HARBOR COMMISSION SPECIAL MEETING

POST 35% SUBMITTAL 12/22/2022

South Harbor Rebuild
City of Cordova
 ALASKA

Harbor Commission questions and answers

SHEET NUMBER	G3A
HARBOR LAYOUT ALTERNATIVES	
ISSUE DATE	12/9/2022

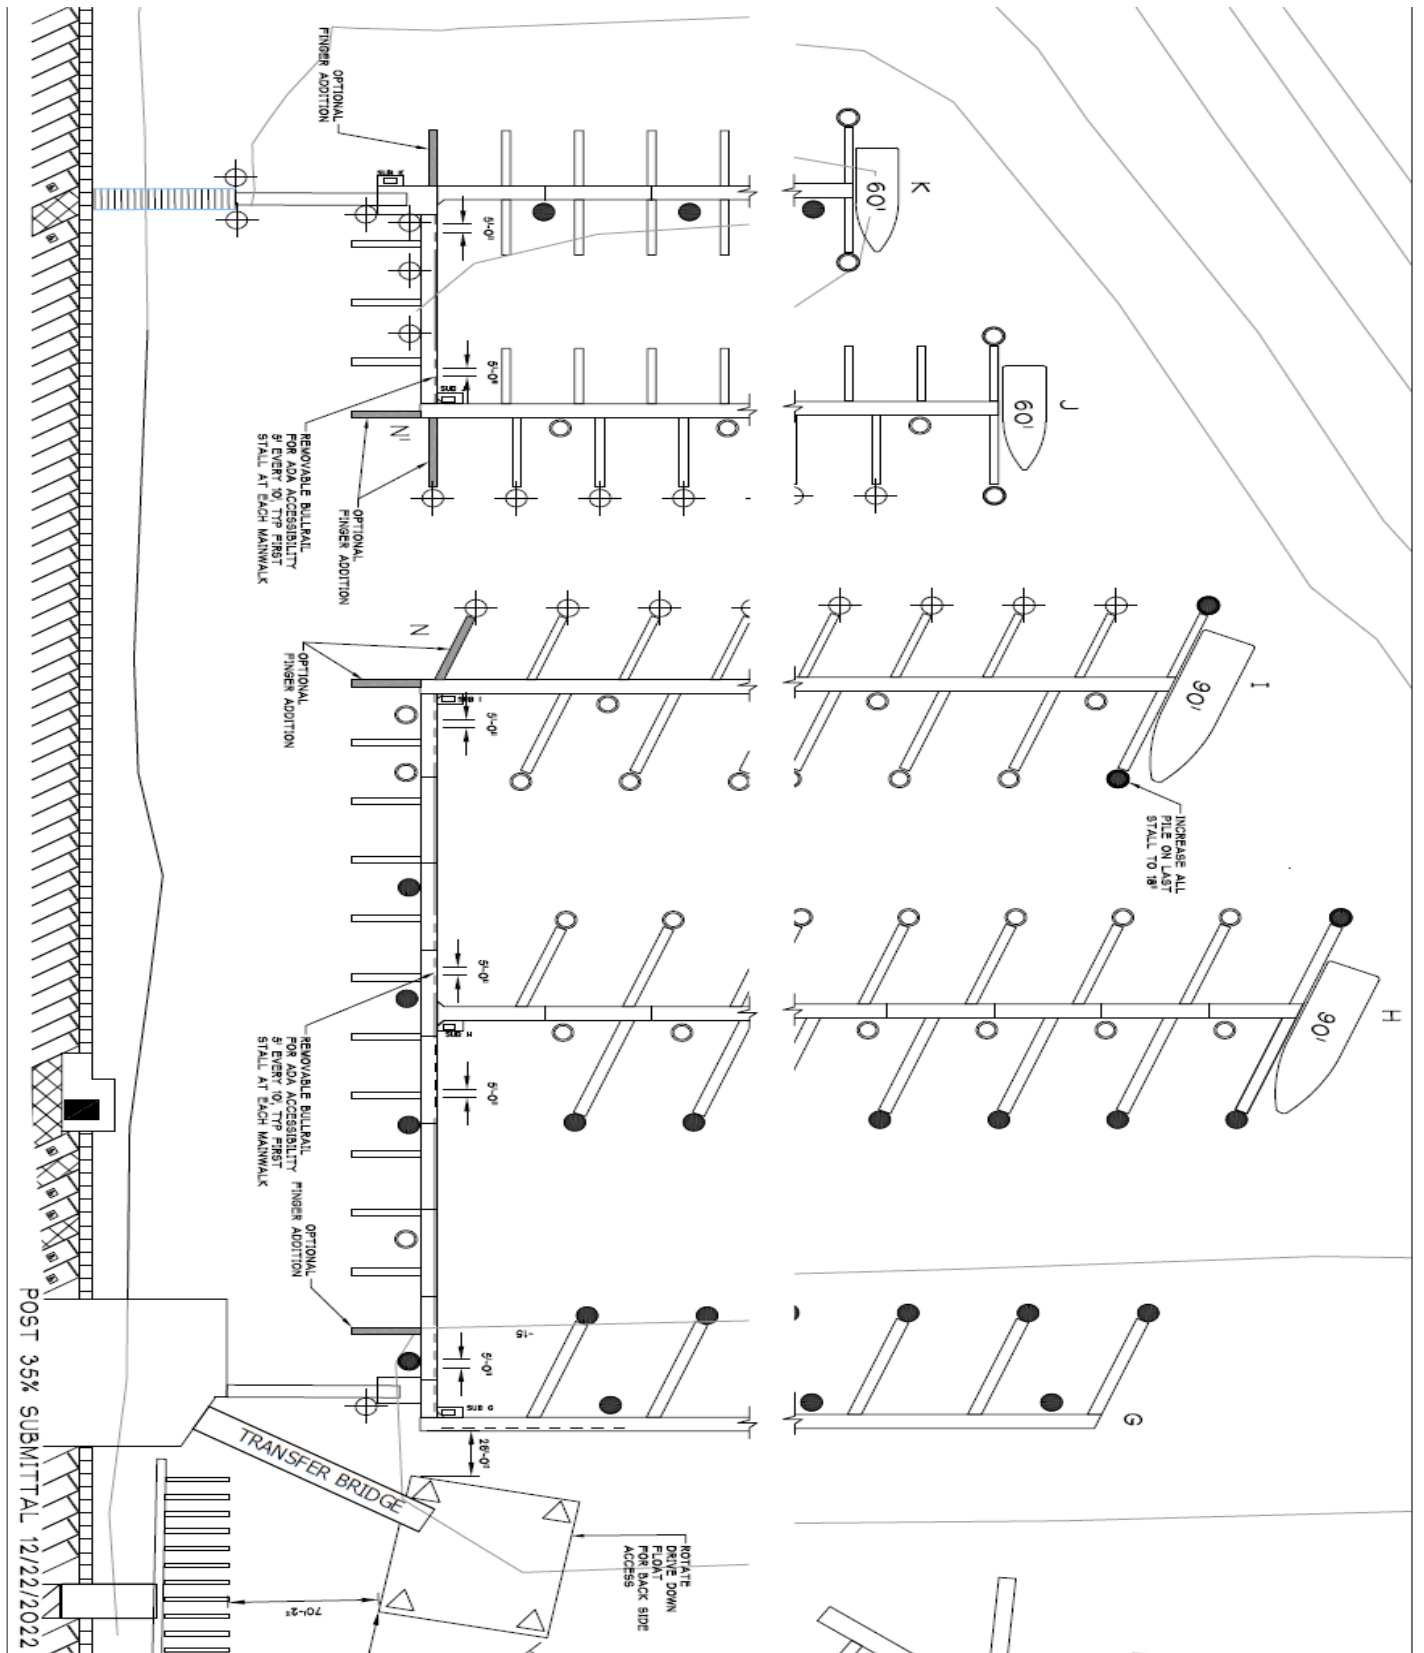
- Can we add additional floats on K, J, I float? Obvious cost increase; is it possible and cost?
 - Based on current budget environment this request is seen as cost prohibitive.

- Can we/should we upsize the piles on the “T” of H, I, J & K to support larger vessels mooring on the T’s or possibly add a pile?
 - The attached drawing shows pile up sized to accommodate larger vessels on the end T’s, up to a maximum vessel length of 90’.

- The attached drawing shows the addition of the five finger floats requested, as well as a possibility for two more to the north of GHI gangway landing.

- We have worked with contractor and will upsize pile on H, I & J floats.
 - Cost Impact:

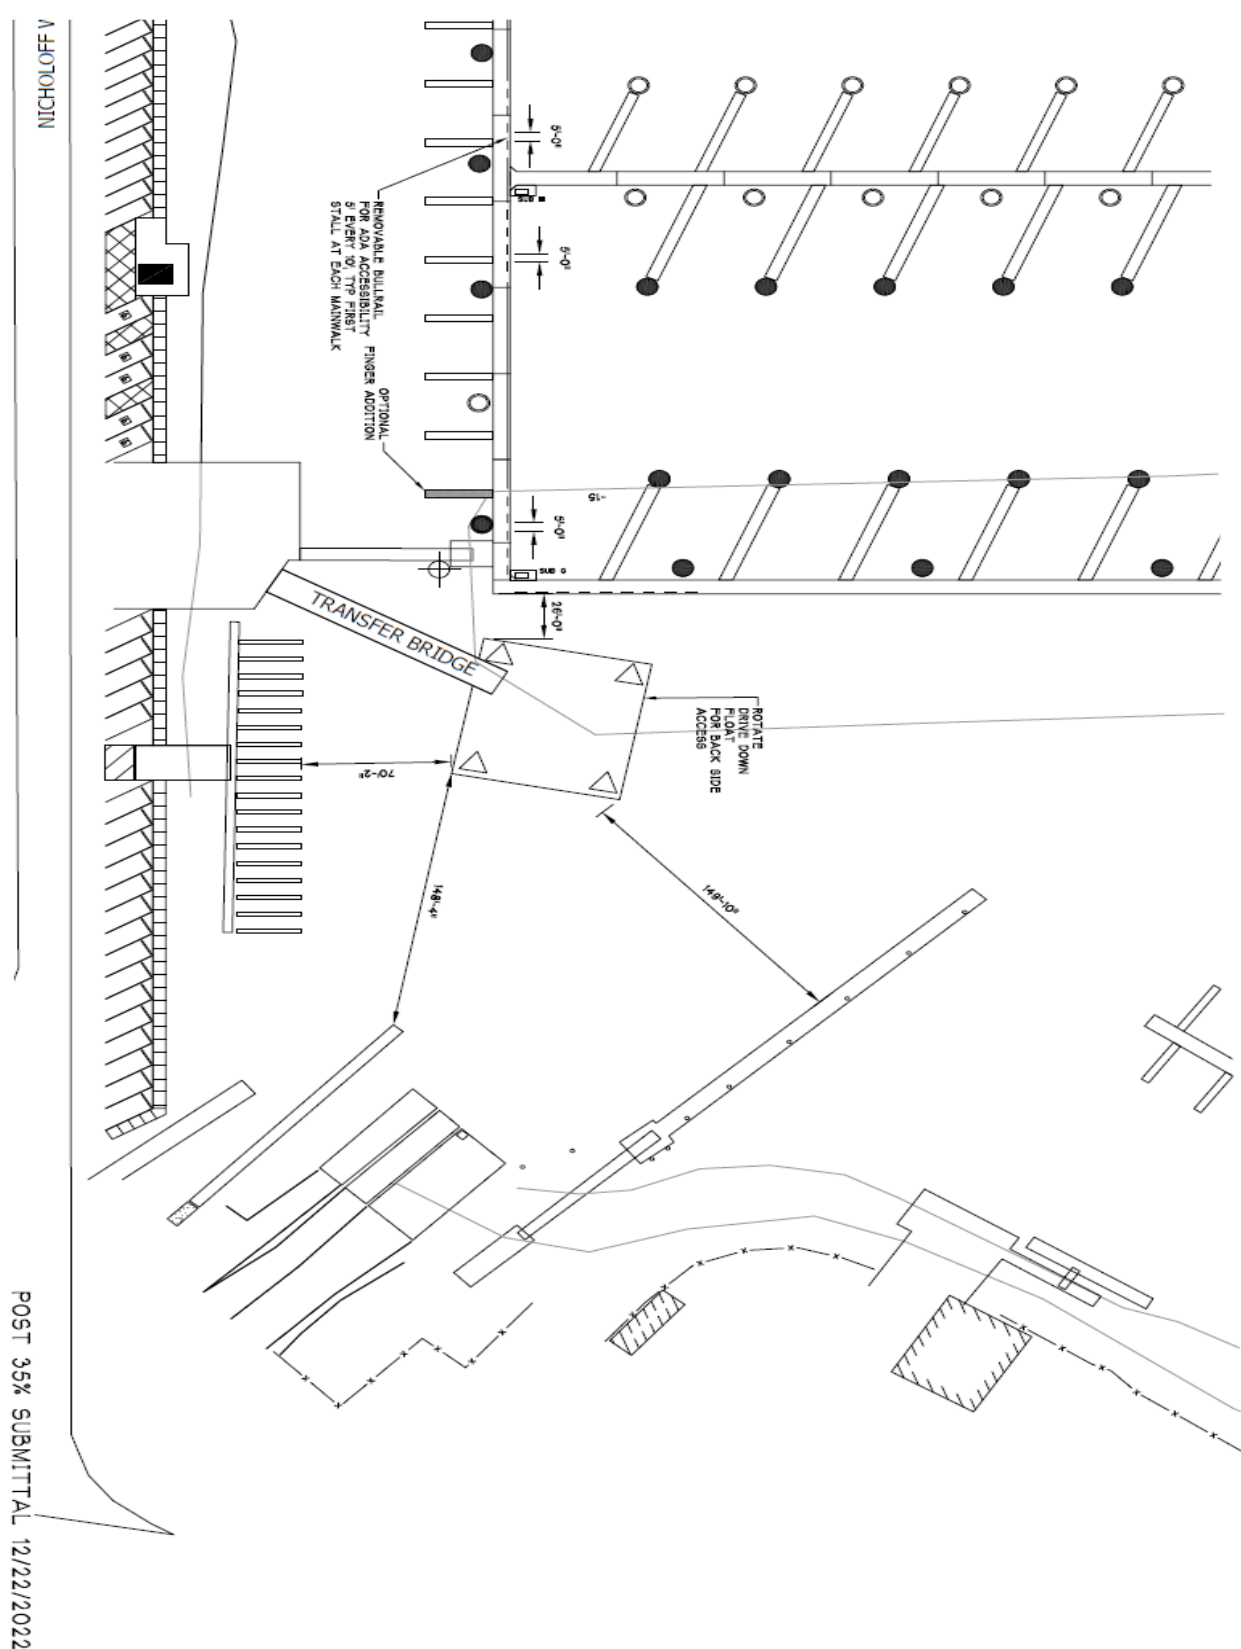
- What are the options for the DDF, move or reorient?
 - See attached drawing for possible alternate positioning of the DDF. This layout does not require any changes to the transfer span.
